CITY OF MOUNTAIN VIEW
MOUNTAIN VIEW, CALIFORNIA
ADDENDUM NO. 2
TO CONTRACT DOCUMENTS AND SPECIFICATIONS
FOR
FIRE STATION NO. 5, PROJECT 09-32

Changes to Construction Drawings

MOUNTAIN VIEW FIRE STATION No. 5

ASK-3

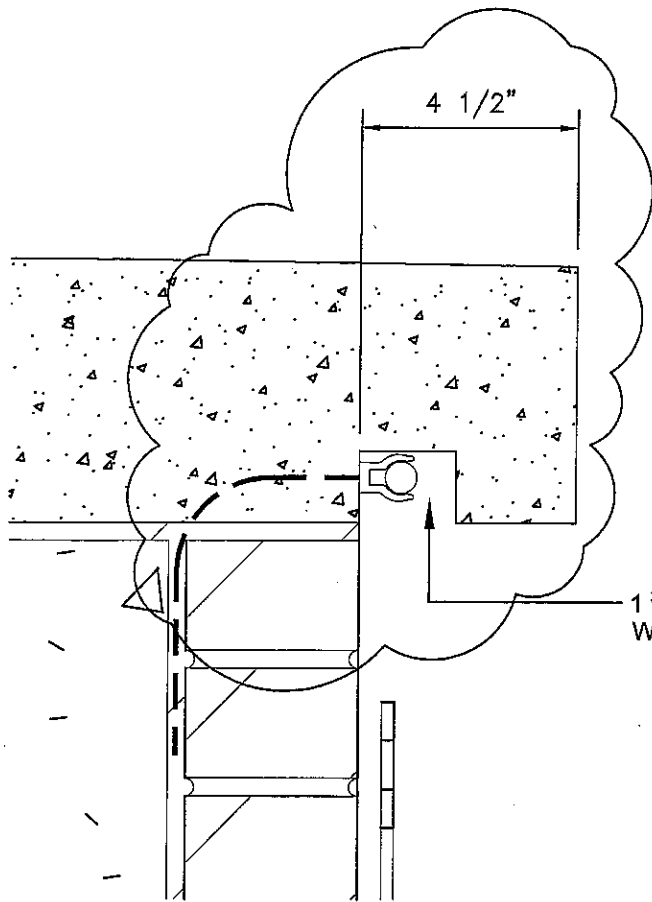
Revise the length of the generator enclosure, slab configuration and site work along the edge of the enclosure as shown on ASK-3.

REVISED ENCLOSURE LENGTH
25'-8"

REVISED DISTANCE
TO GRIDLINE
7'-6"

Sketch Number: ASK-4

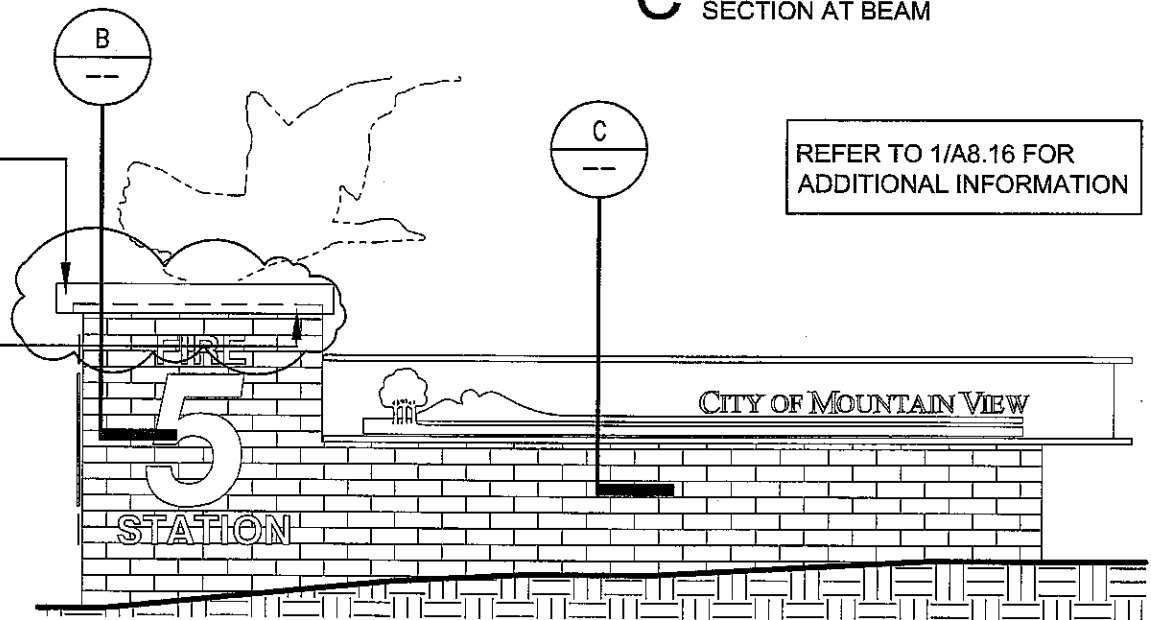
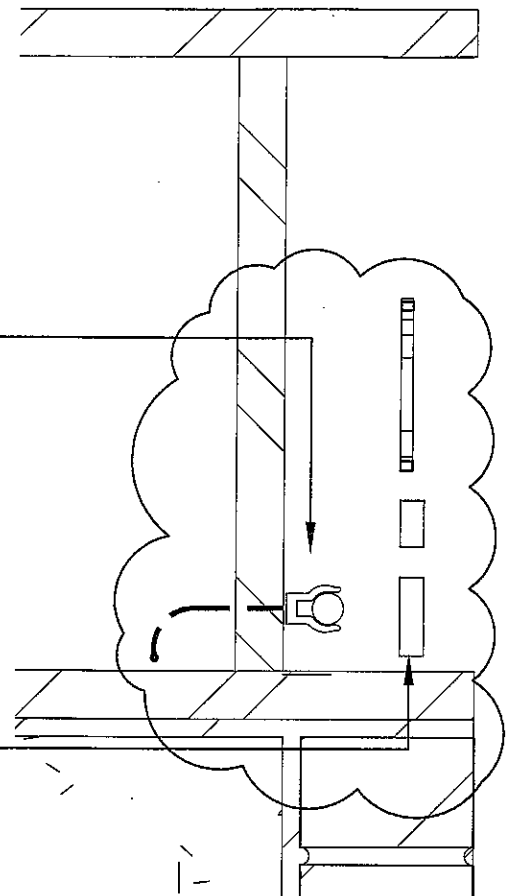
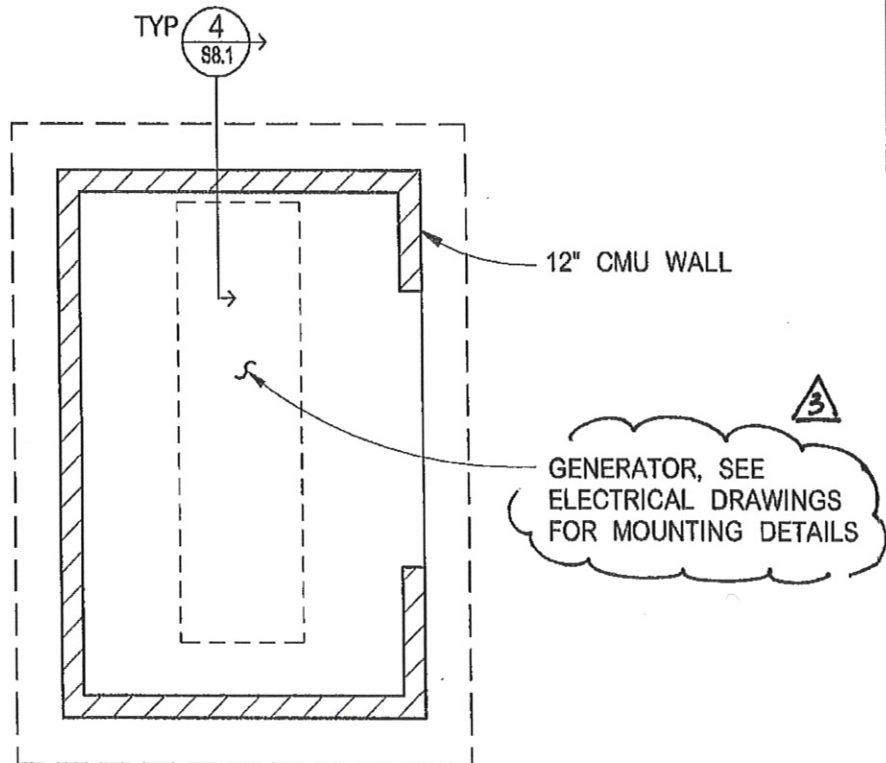
Revise the monument sign details as shown on ASK-4, to accommodate concealed lighting.

CONTINUOUS LED STRIP
CONCEALED BEHIND
GRAPHICS

1 3/4 x 2 1/2" REVEAL
W/CONTINUOUS LED STRIP

Issued As:
Sketch Number: SSK -4
Date: 5/24/10

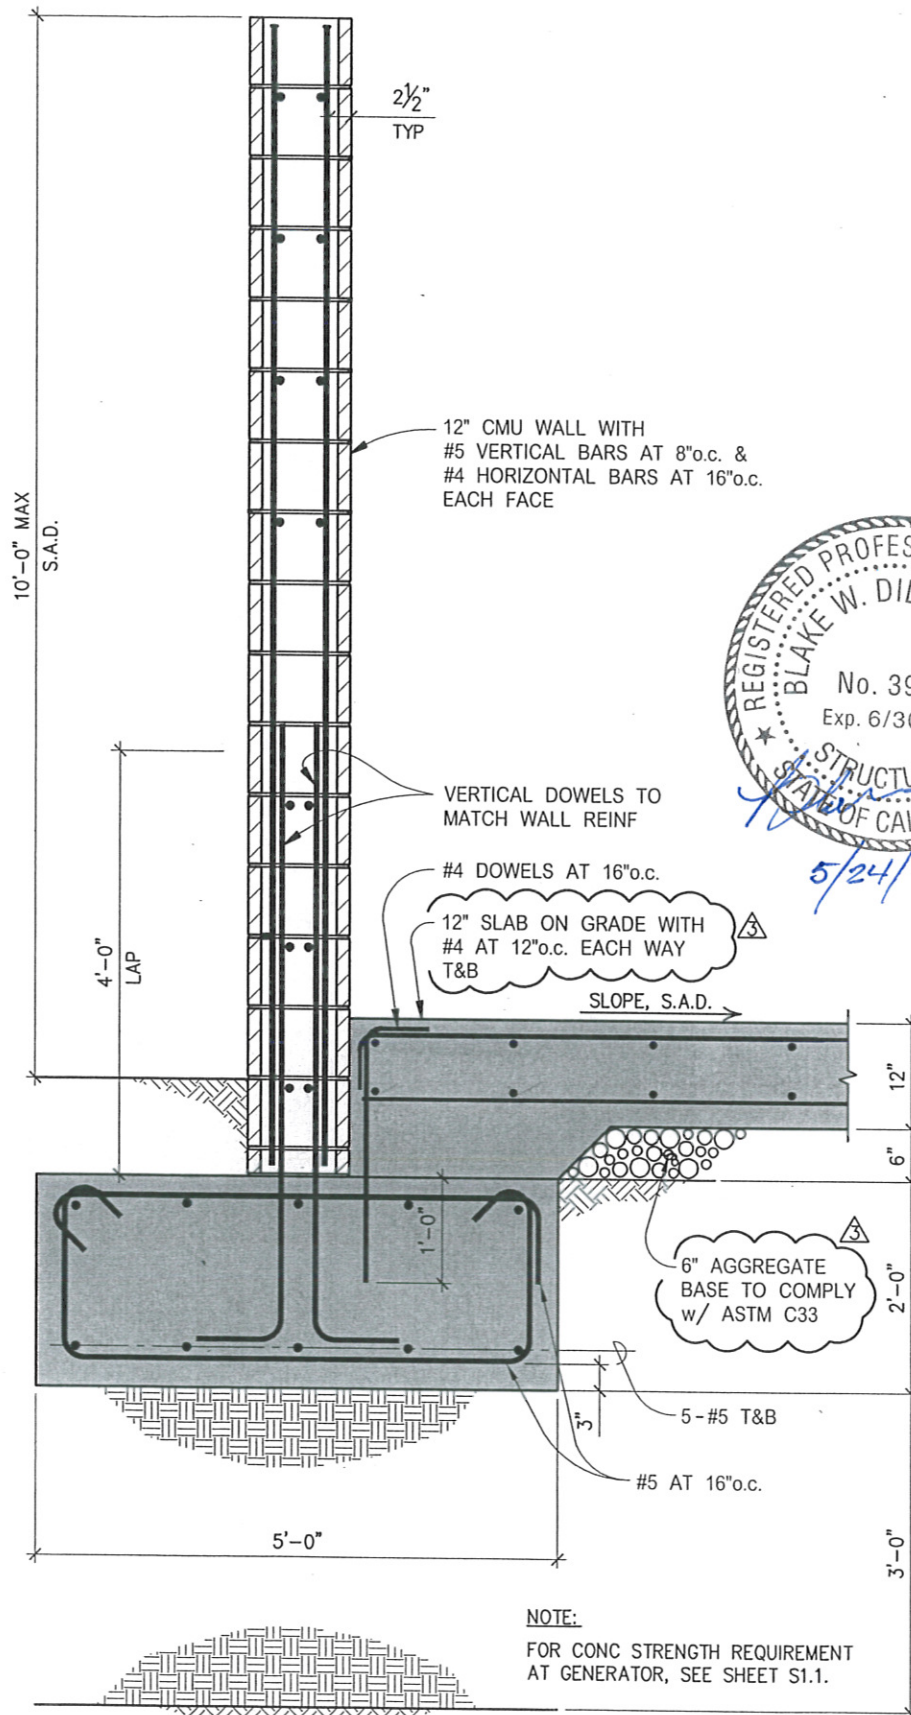
Revise detail 2 as indicated on SSK-4.

Sketch Number: ESK-07

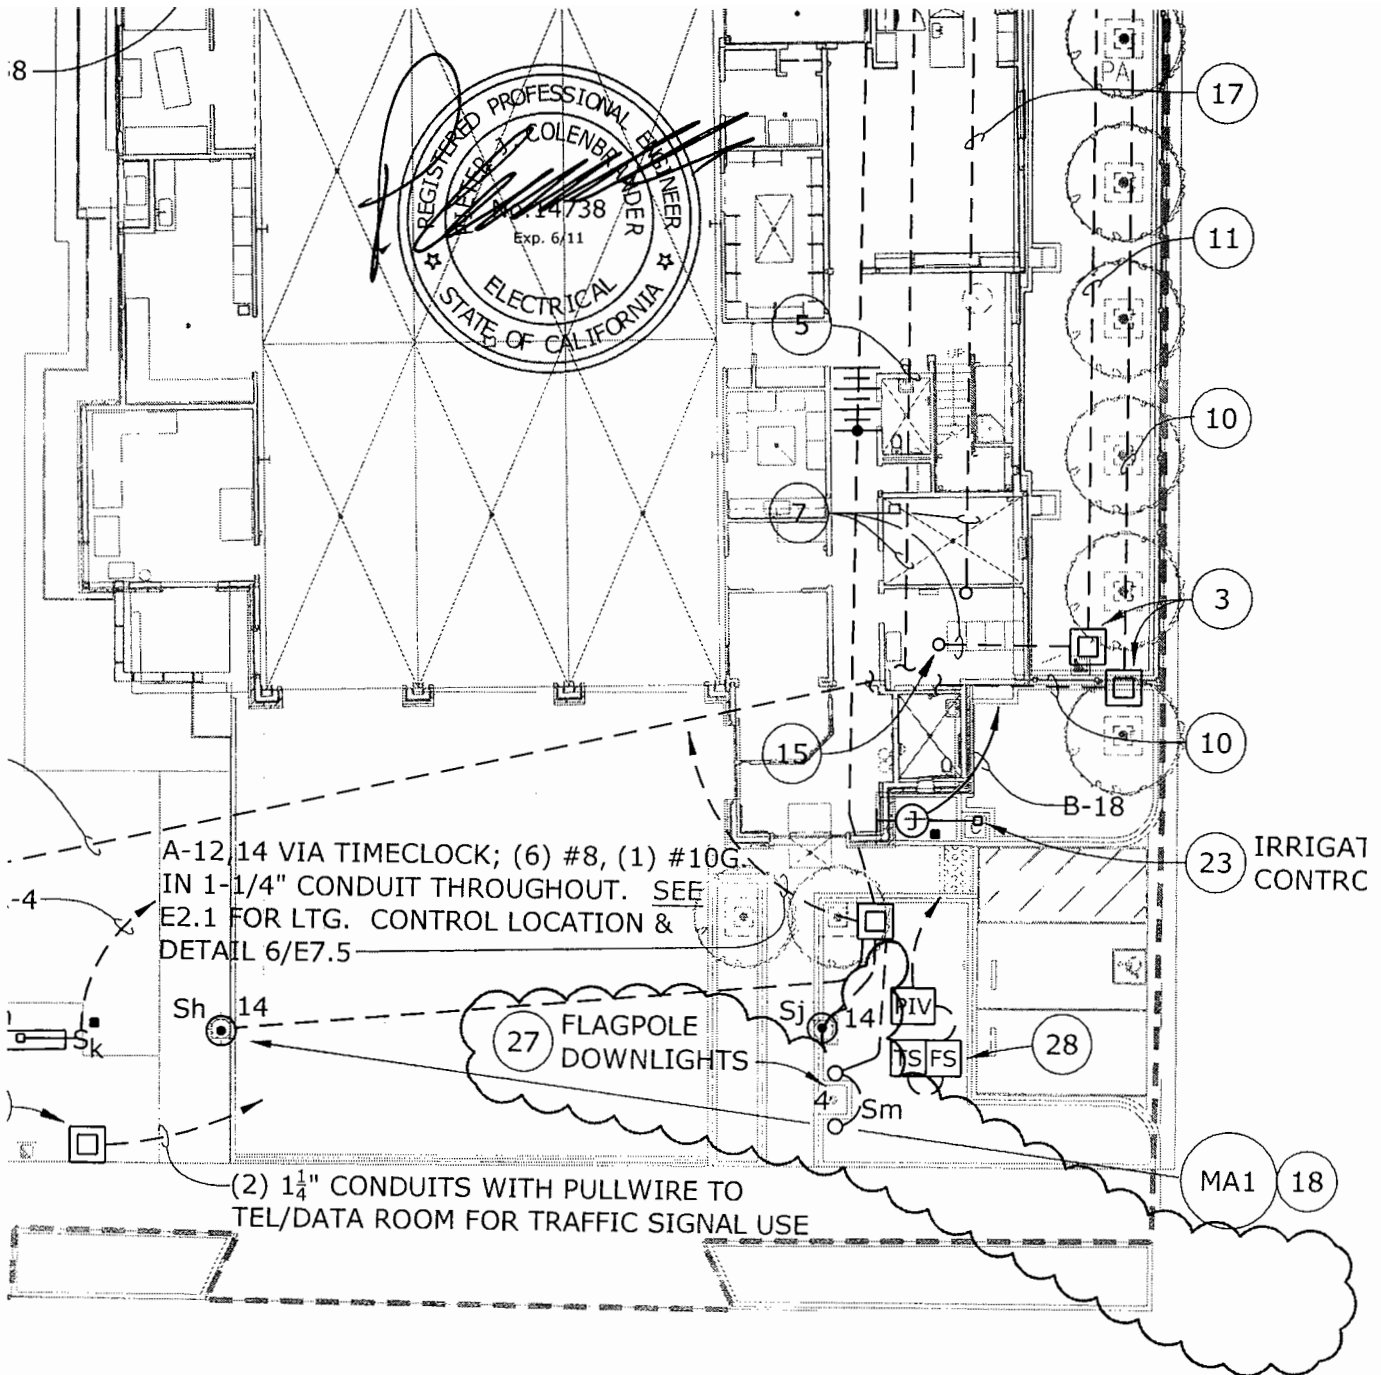
Sketch ESK-07: Remote generator load bank added. Note 4 leader line adjusted at secondary service conduits.

Title: PARTIAL PLANS -
DETAIL 1/E4.1
Dwg. Ref.: E4.1

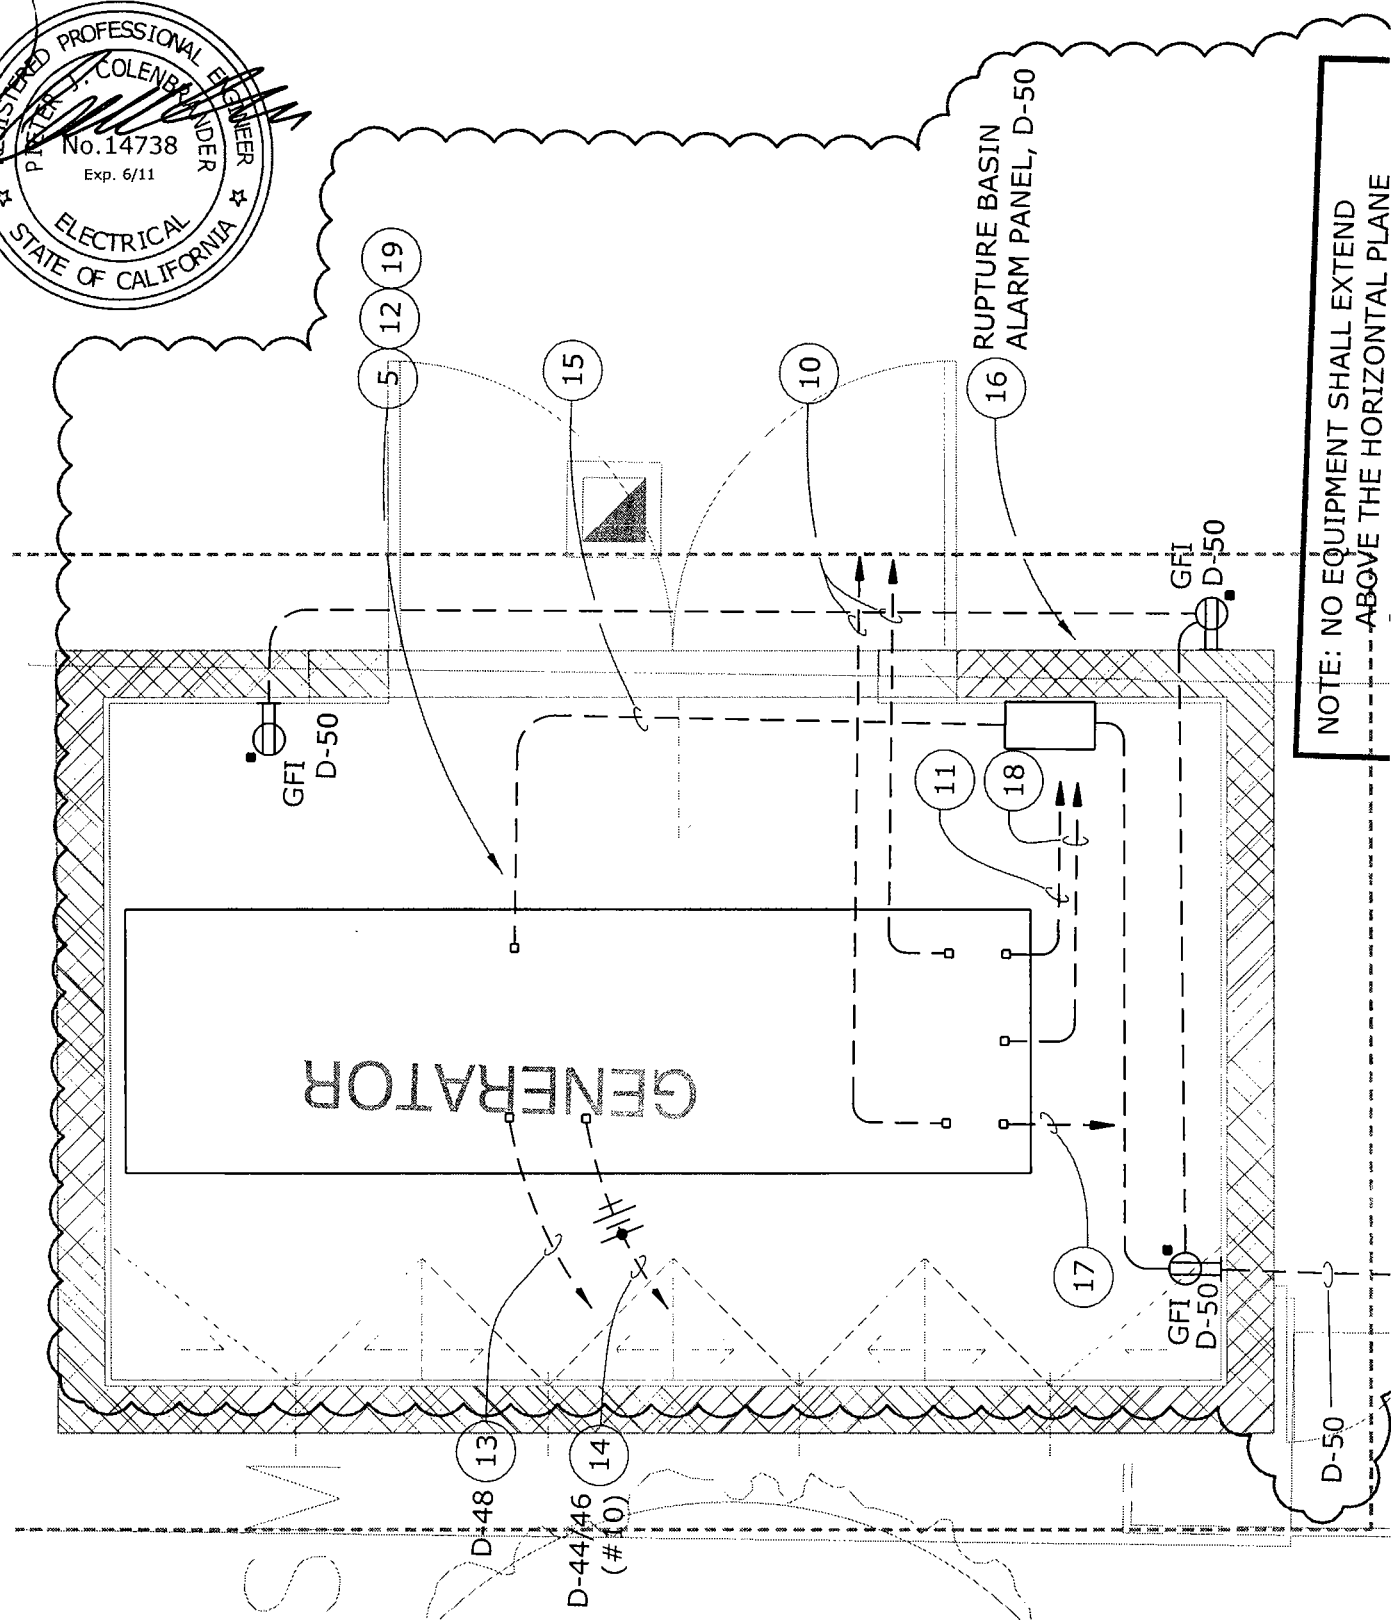
Sketch ESK-12 & 13: Generator mounted load bank replaced with a remote generator load bank, which is to be located in the main electrical equipment yard. Note added for housekeeping pad to be placed in front of metering section.
